Report: TAB Report
Function: Test, Adjust, & Balance
Date: 10/30/2025
Completed By: National TAB

10-20-25 WAWA #8084 SPRINGFEILD, PA

Project: 10-20-25 WAWA #8084 SPRINGFEILD, PA

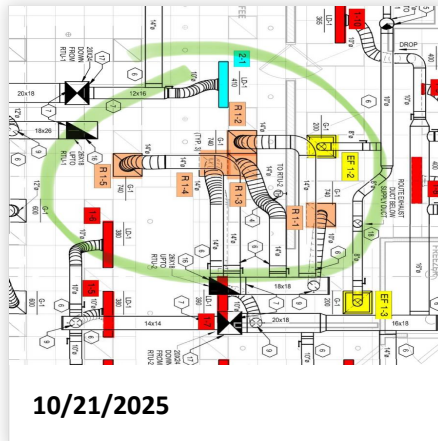
Issue Name : RTU-1 Missing Return Grille and Grille out of place
Description : The return grilles for RTU-1 do not match design. There is one grille missing, and another not placed where intended by design. Recommend adding the the missing grille and organizing the grilles within planned design.
Created By : National TAB **Assigned To :** National TAB - Will Turnbough
Status : Open
Priority : Medium **Asset Tag :**
Originated Date : 10/21/2025 - Ryan Ash - National TAB
